Access Compliance Report

Public Rights-of-Way

(Curb Ramps)

Intersection ID: 42934	Main Street: HOLLY PARK DR	Cross Street: BALLINA WY	Location:	W
ADA ID: F3C4095A60B2	Ramp Type: BlendTrans1	Initial Pass/Fail: Fail	Overall Compliance: No	Severity Score: 10
Codes/Mitigation Info/Possible Solution		Field Measurements/Component Compliance

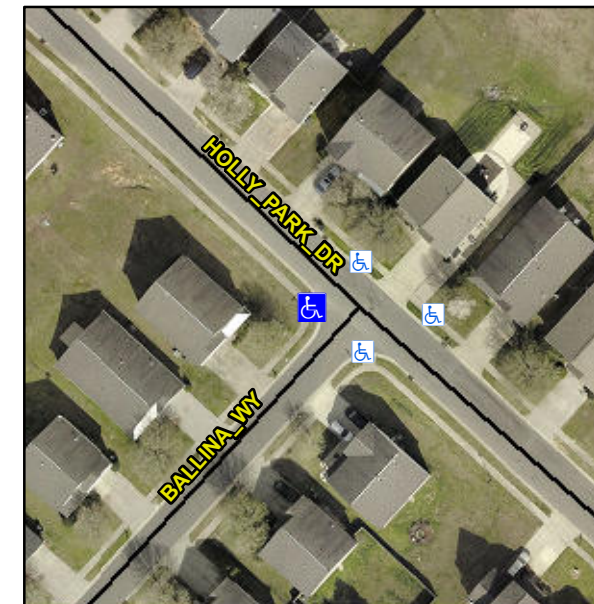
Not Found, R304.5.1, R304.5.3

Compliance	Description	Data	Compliance	Description	Data
N/A	Ramp Length (in)	46.0	Yes	BlendTrans Slope (%)	1.0
No	Ramp Width (in)	41.0	No	BlendTrans XSlope (%)	2.4
N/A	Flare Type LT	N/A	N/A	Flare Type RT	N/A
N/A	Flare Slope LT (%)	N/A	N/A	Flare Slope RT (%)	N/A
N/A	Flare Traversable LT?	N/A	N/A	Flare Traversable RT?	N/A
N/A	Landing Length (in)	N/A	N/A	DWS Provided?	N/A
N/A	Landing Width (in)	N/A	N/A	DWS Contrast?	N/A
N/A	Landing Slope (%)	N/A	N/A	DWS Length (in)	N/A
N/A	Landing X Slope (%)	N/A	N/A	DWS Full Width?	N/A
N/A	Landing Curb? (Y/N)	N/A	N/A	DWS Offset (in)	N/A
N/A	Shared Landing?	N/A			
N/A	Gutter Ponding?	N/A	N/A	Gutter Slope (%)	N/A
N/A	Gutter Lip Ht (in)	N/A	N/A	Gutter X Slope (%)	N/A
N/A	Painted X Walk1?	No	N/A	Painted X Walk2?	No
	X Walk 1 Direction	To SE		X Walk 2 Direction	To NE
	X Walk 1 Width (in)	N/A		X Walk 2 Width (in)	N/A
	X Walk 1 Slope (%)	6.1		X Walk 2 Slope (%)	3.9
	X Walk 1 X Slope (%)	2.9		X Walk 2 X Slope (%)	6.3

N/A	Ramp inside XWalk1?	N/A	N/A	Ramp inside XWalk2?	N/A
	Road Slope (%)	2.3		Clear Space?	N/A
	Road X Slope (%)	4.7	N/A	Clear Space to XWalk (in)	N/A
N/A	Any Obstructions?	N/A	N/A	Storm Grate/Utility Hazard?	N/A
	Obstruction Type			Storm Grate/Utility Type	
		N/A			N/A
			Yes	Surface Condition? (G/P)	Good
			No	Curb Slope (%)	7.0

Remove & Replace Curb Ramp With Two New Directional Ramps or Equivalent.
